**METROPOLITAN DEVELOPMENT COMMISSION  
HEARING EXAMINER**

**Case Number:** 2025-CZN-802 / 2025-CPL-802 / 2025-CVR-802 (Amended)

**Property Address:** 5801 Mills Road (Approximate Addresses)

**Petitioner:** Grand Communities, LLC, by David Gilman

# Exhibit A

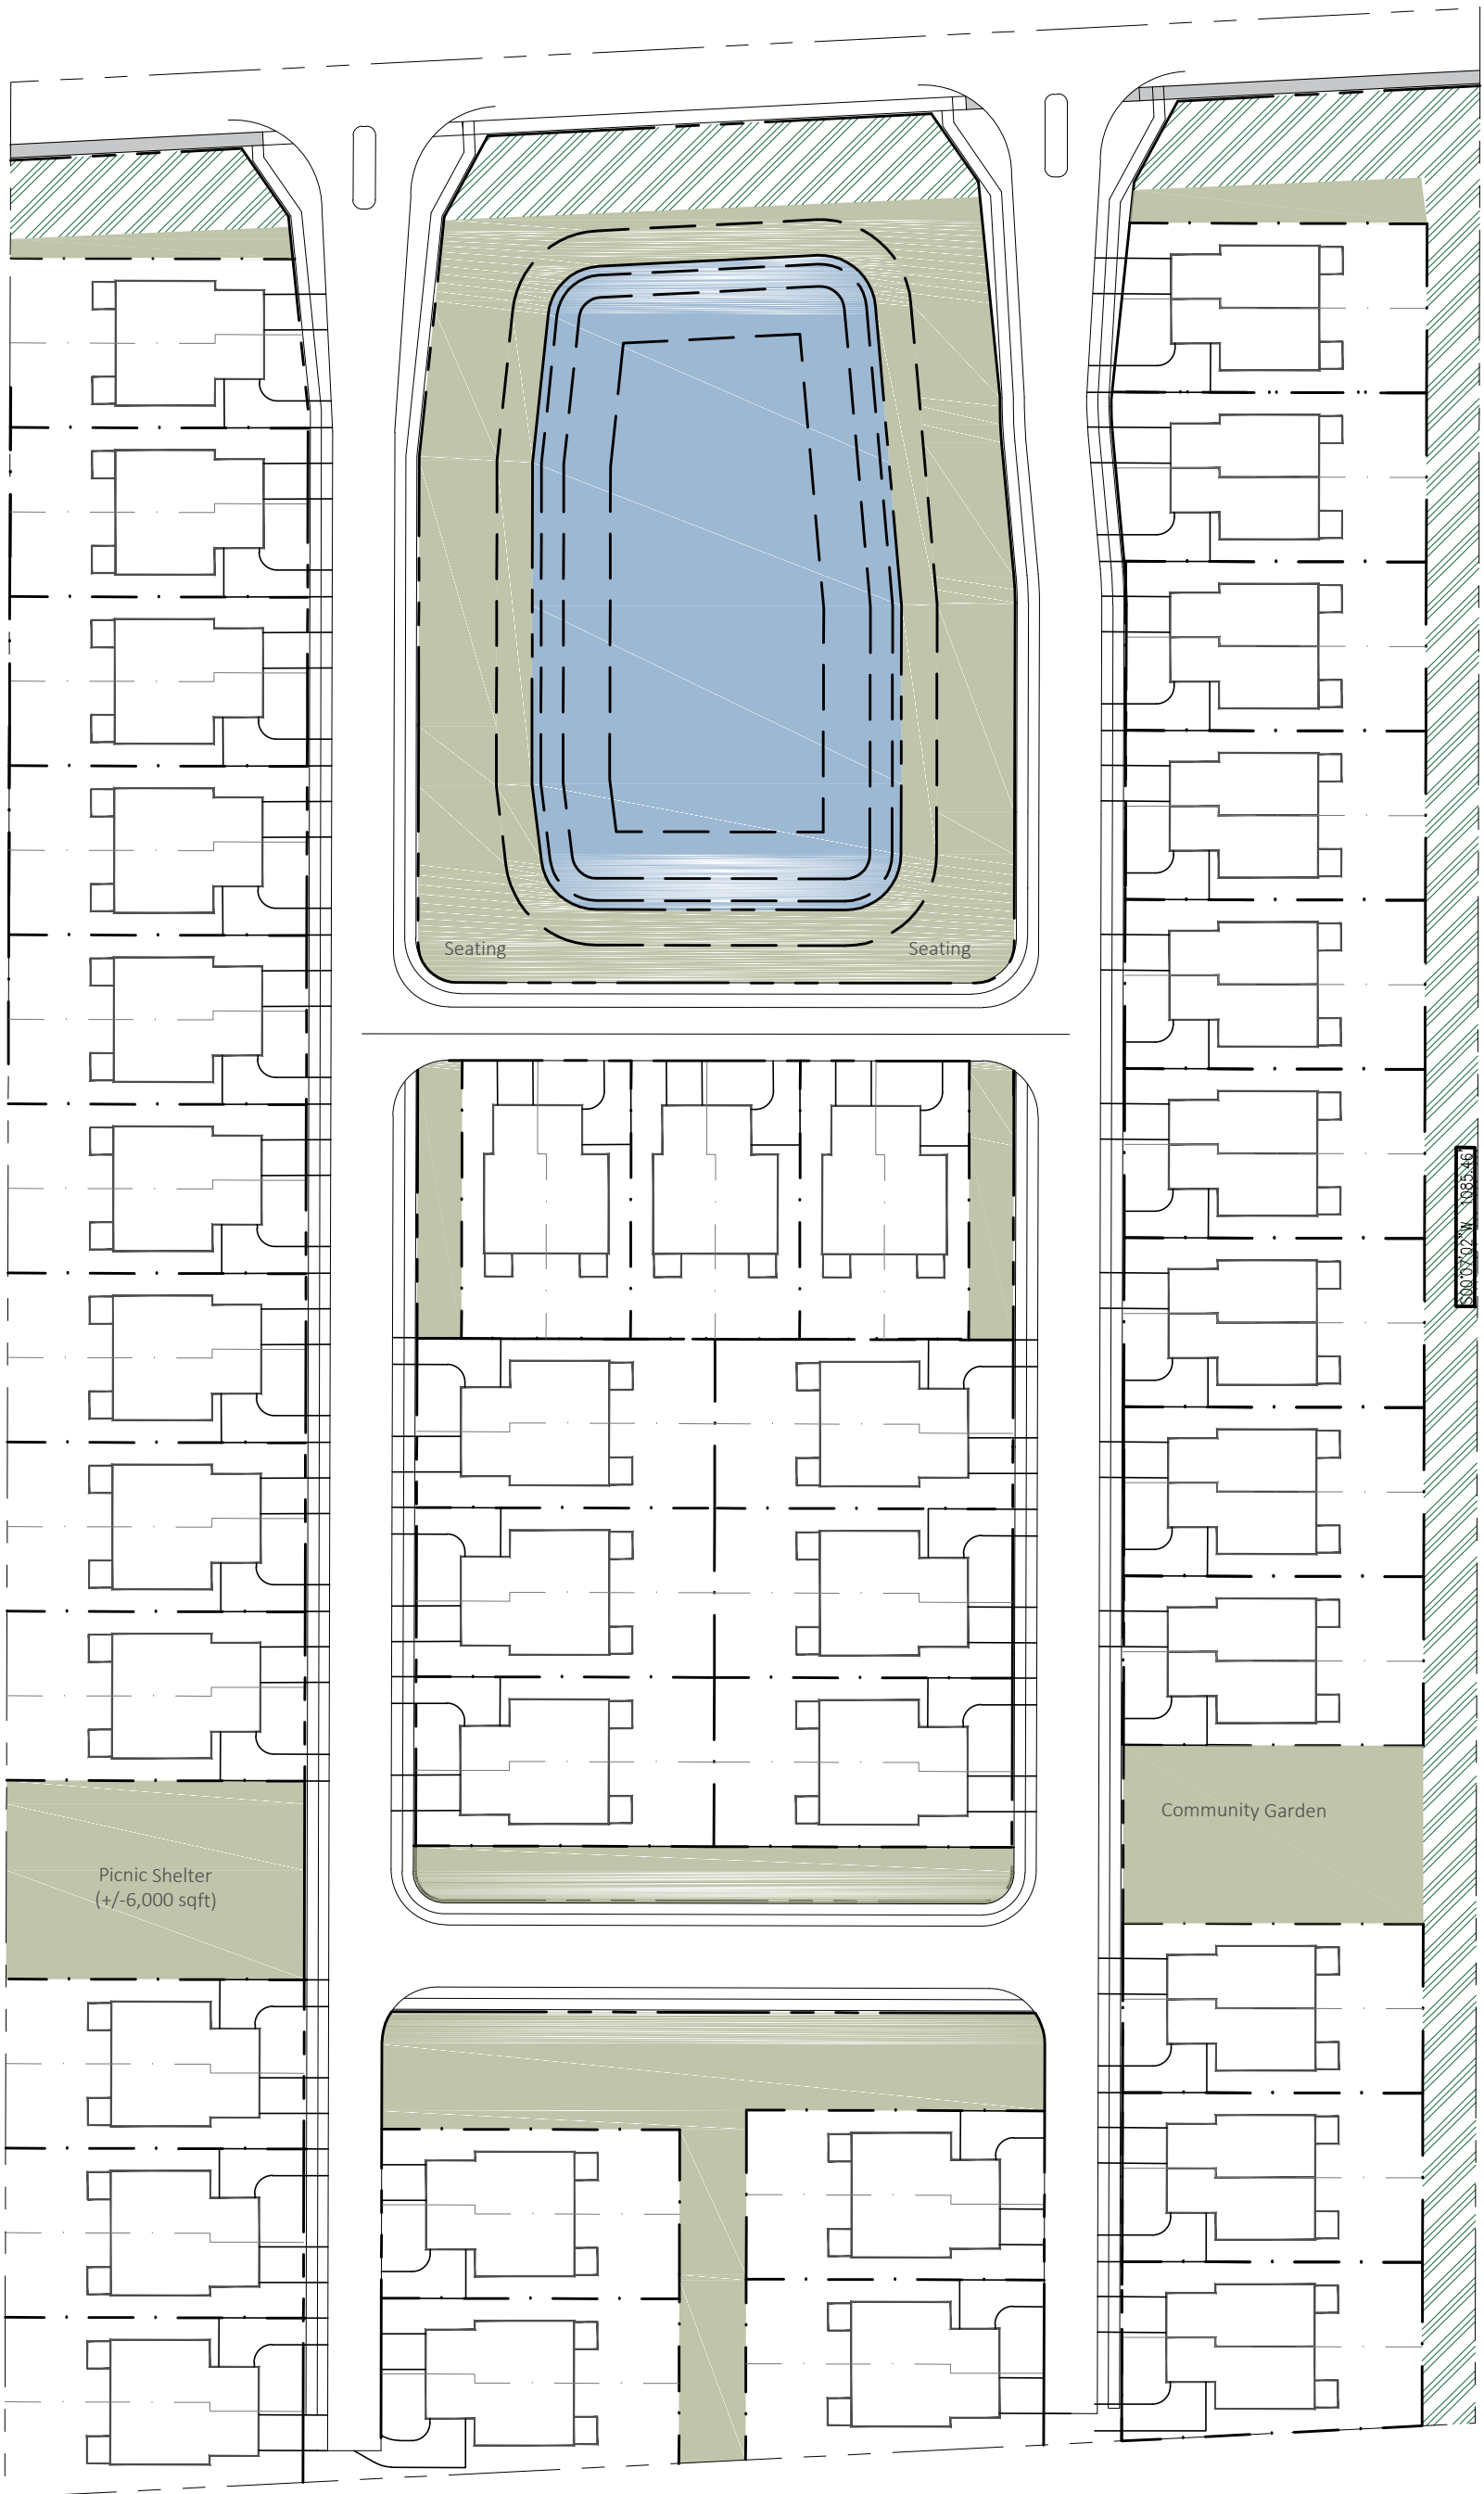
**Street Connectivity:** The proposed plat includes two dead-end streets, which do not align with best practices for well-connected street networks.

The submitted primary plat (dated 1/3/2025) proposes five-foot sidewalks, whereas **Sec. 744-302. B.1** requires a minimum sidewalk width of six feet in the D-4 zoning district. . The plat must be revised accordingly.

The proposed development does not comply with **Sec. 741-310. B.2**, which mandates additional open space components for subdivisions exceeding 20 dwelling units. The submission does not meet the required standards for open space amenities. The plat must be revised to show 2 additional amenity components.

**Staff Findings:** Dead-end streets pose a public health and safety as they create problems for municipal services, along with fire department, they also create havoc for trash services, snow removal, street maintenance, postal services and more.

**Staff Findings:** The condition upon which the request is based on is due to the petitioner’s interest in having 10 more lots. A reduction in the number of lots or a reconfiguration of the layout would dismiss the need for a waiver.

**Staff Findings:** Simply making the streets private does not solve the problem as private streets are only allowed in the zoning ordinance under specific circumstances, that this petition does not qualify. The easy solution to this would be to reduce the number of lots.

**Staff Findings:** The grant will be injurious as private streets are not allowed by the zoning ordinance. Dedicated and accepted for maintenance is a crucial part as the maintenance of streets will fall on the HOA. Street maintenance is not cheap. Should the HOA disband the only street to these lots would be left in disrepair. The petitioner is requesting that only these 230 feet be dedicated private while the rest of the subdivision has public streets. That would be a heavy burden on just 10 lot owners.

**Staff Findings:** Staff finds no practical difficulties as the petitioner can have a subdivision with the addition of the 10 lots and still have 64 dwelling units. This Variance request is based solely on the desire for more homes.

**Concept Plan**

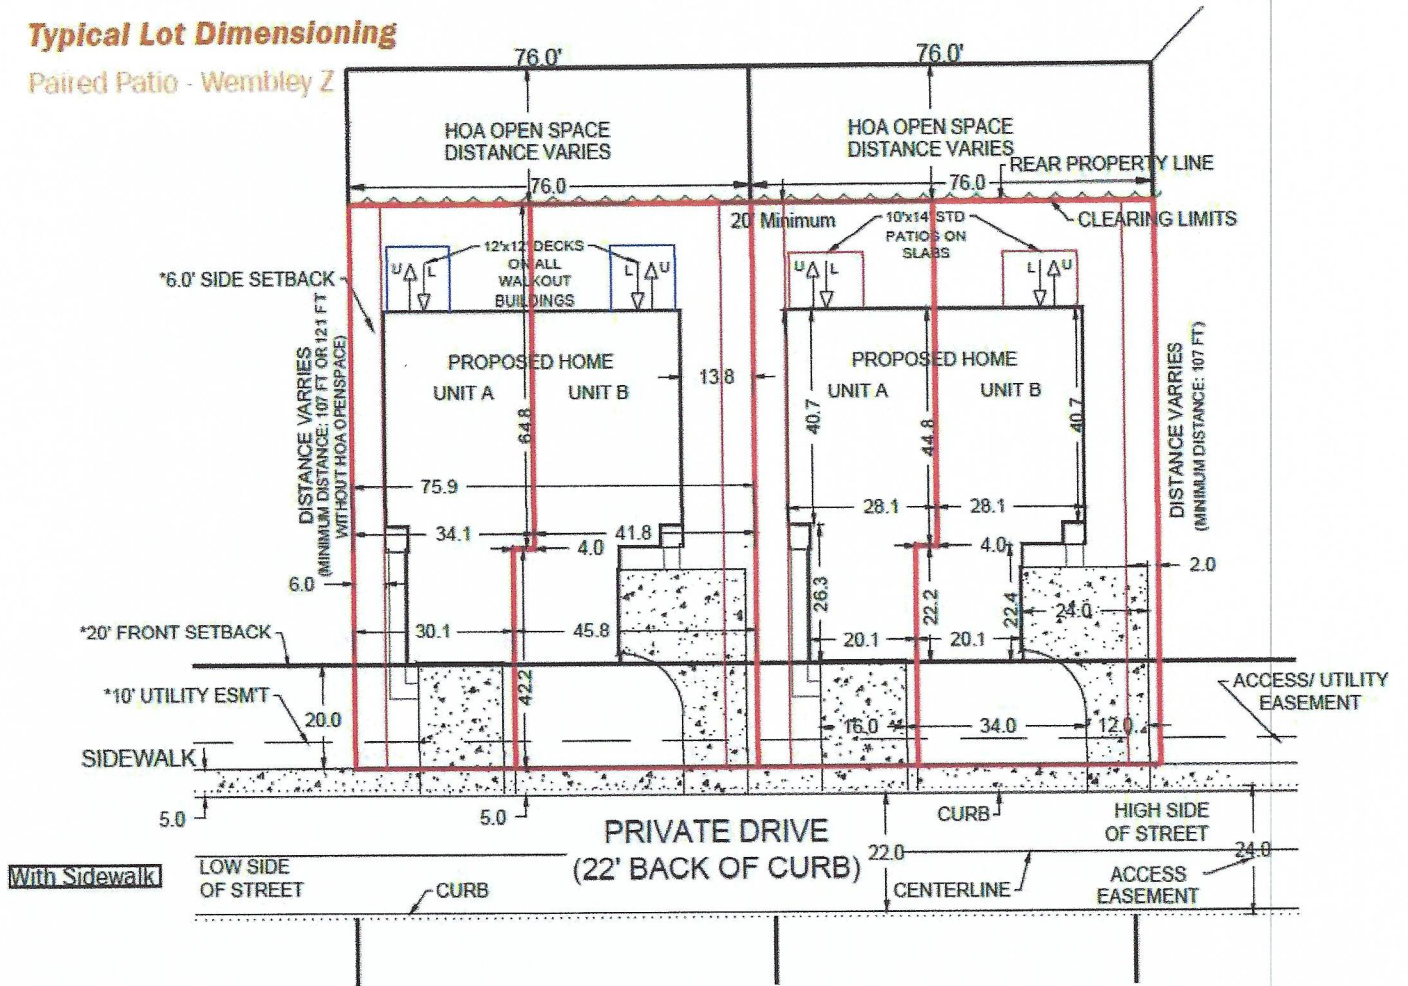
The subdivision layout includes two permanently dead-ended streets, necessitating the following waiver requests:

**Request:** The applicant is proposing two streets that have permanent dead ends.

- **Public Service Access:** Dead-end streets create challenges for fire, emergency services, trash collection, snow removal, and street maintenance.
- **Alternative Solutions:** A reconfiguration or reduction in lot count could eliminate the need for these waivers.
